**CITY OF LONG BEACH  
CITY COUNCIL SUPPLEMENTAL AGENDA**

SOUTH REGION HIGH SCHOOL # 4  
Los Angeles Unified School District

**RE: Comments on Draft Environmental Impact Report  
Proposed South Region High School No. 4  
State Clearinghouse No. 2005041116**

SITE OPTION # 1A

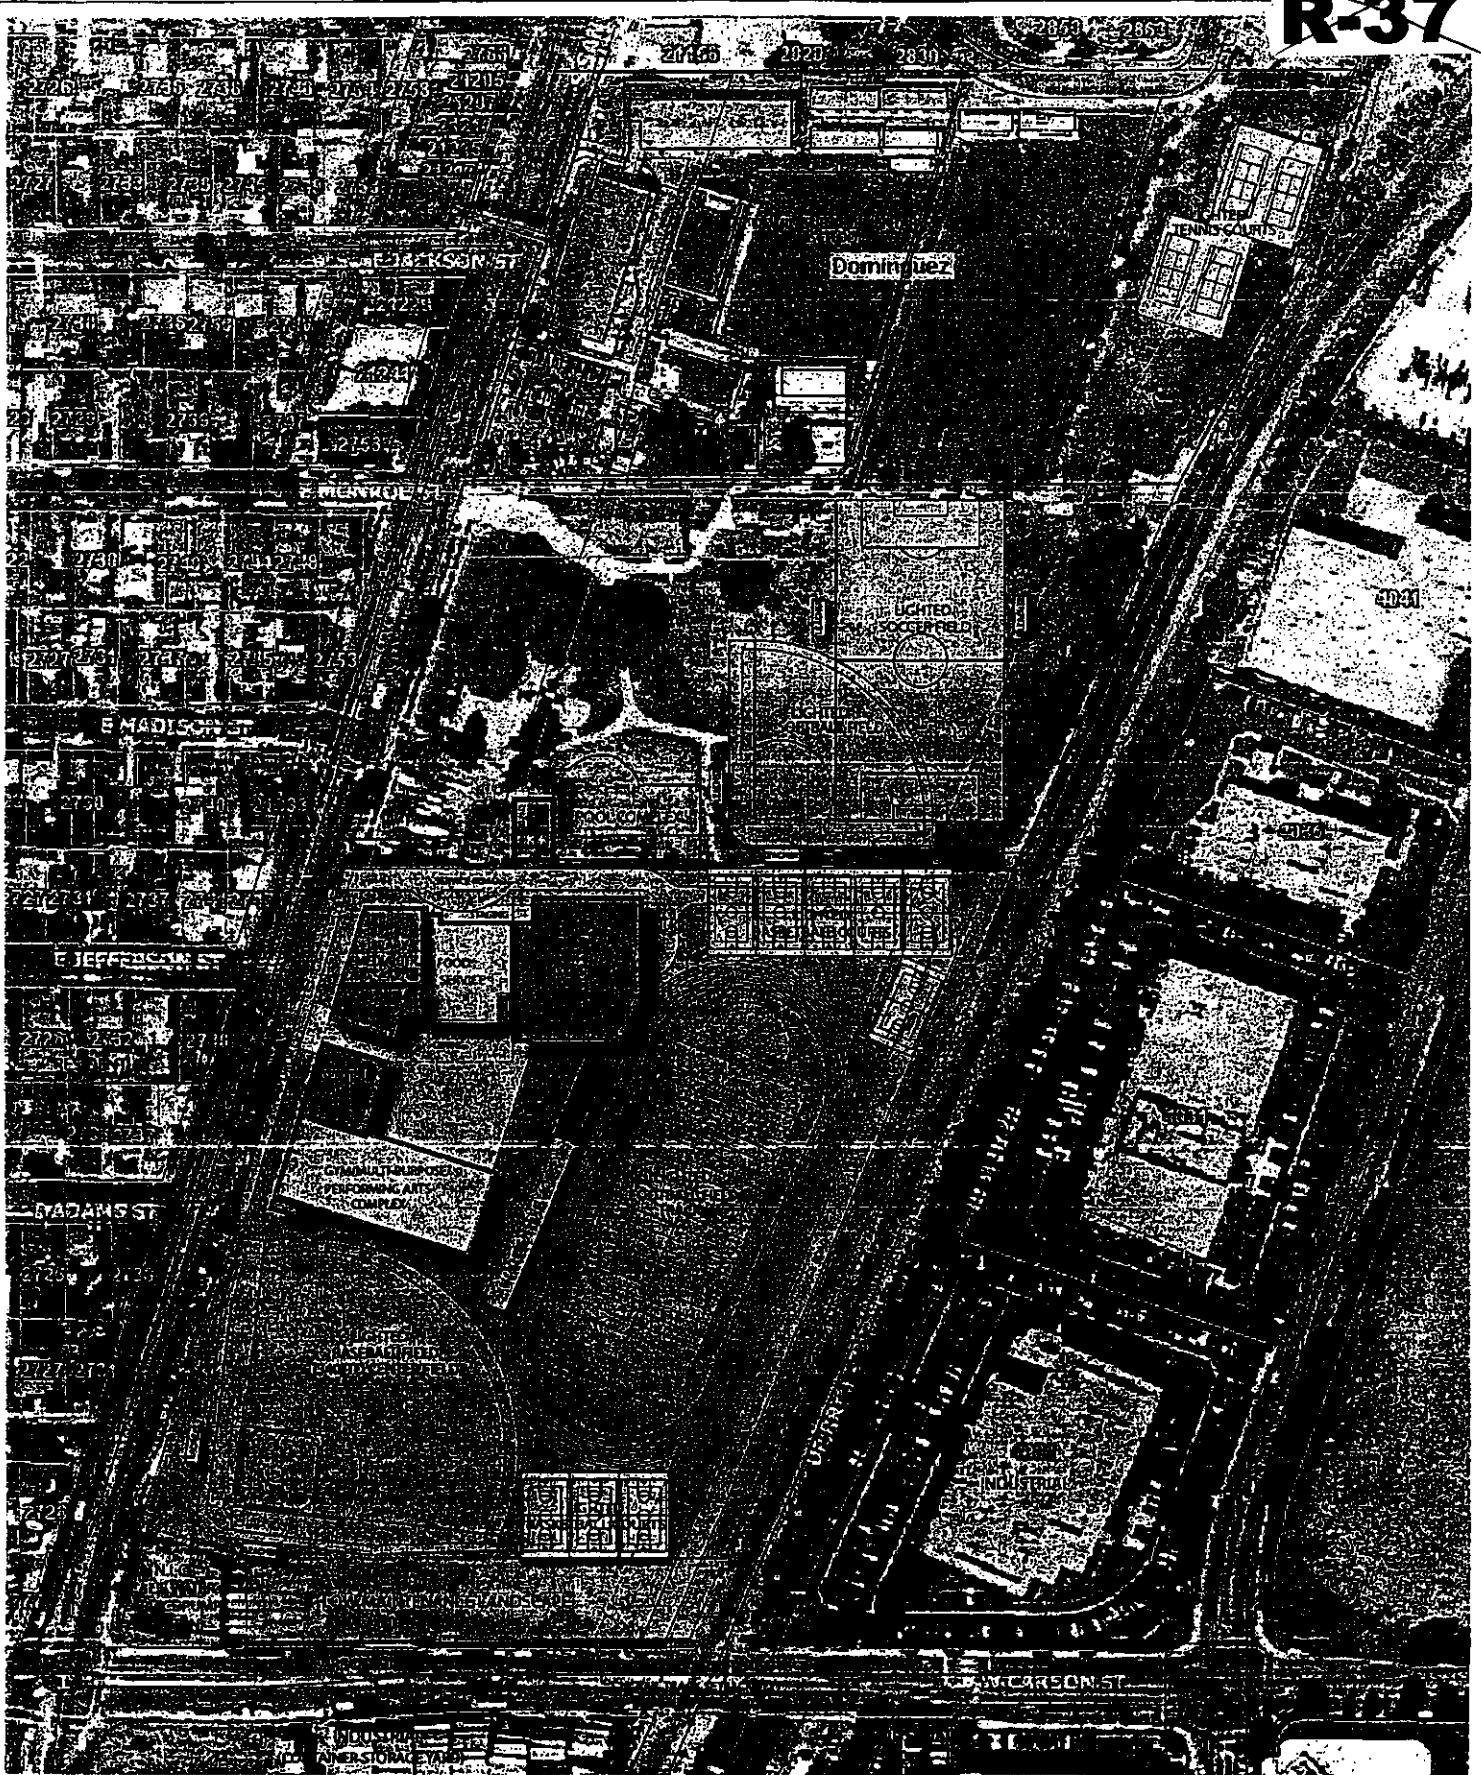
This proposed high school, known as South Region High School No. 4, would provide 182,000 square feet of facilities with approximately 67 classrooms to serve 1,809 students in grades 9 through 12 (see attached map). The project would include a library/media center, a performing arts center, two gymnasiums, administrative offices, a police/security facility, and space for ancillary uses. Athletic facilities and recreational space would include a lighted stadium to accommodate various sports fields as well as separate basketball, tennis and handball courts. Additionally, a proposed joint use agreement with the City of Carson would permit the construction and use of a softball field in Dominguez Park, which abuts the project site northern boundary. A total of 168 parking spaces would be provided in an underground on-site structure for school faculty and staff only. There would be no on-site student or visitor parking areas.

The EIR indicates that an on-site bus drop off zone will be provided; however, it is unclear from the Site Plan where such a zone would be located or how a bus would enter, maneuver within the project site, and leave the project site. Since a number of the internal drivable pathways traverse athletic facilities, primary walkways, and assembly areas, bus travel within the project site could be restricted as well as pose significant student safety issues.

- The recirculated EIR must accurately show the proposed on-site school bus drop-off location and provide a thorough analysis of this drop-off area on the surrounding street system.
